DPC-NE-2005A, Rev. 1

**DUKE POWER COMPANY
THERMAL-HYDRAULIC
STATISTICAL CORE
DESIGN METHODOLOGY**

SAFETY EVALUATION BY THE OFFICE OF NUCLEAR REACTOR REGULATION
RELATING TO THERMAL-HYDRAULIC STATISTICAL CORE DESIGN METHODOLOGY

Response to Request for Additional Information

FIGURE 2

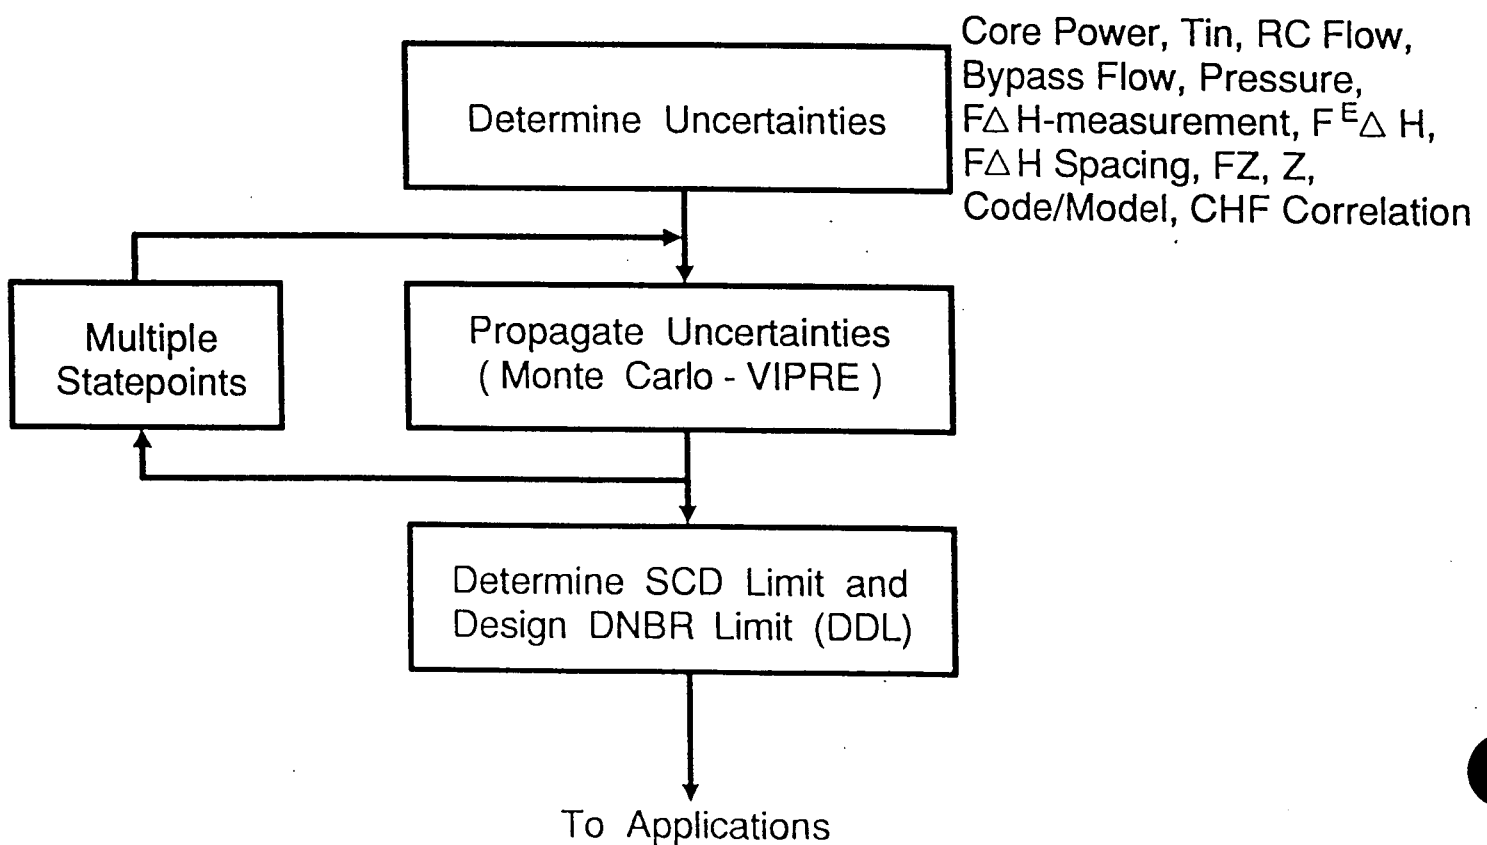
Additionally, the flow chart in Figure 2 also contains a typo. The Propagate Uncertainties box should have the words (Monte Carlo - VIPRE) underneath. The RSM is not used at all in the revised method described by the report. A corrected page 30 is also included.
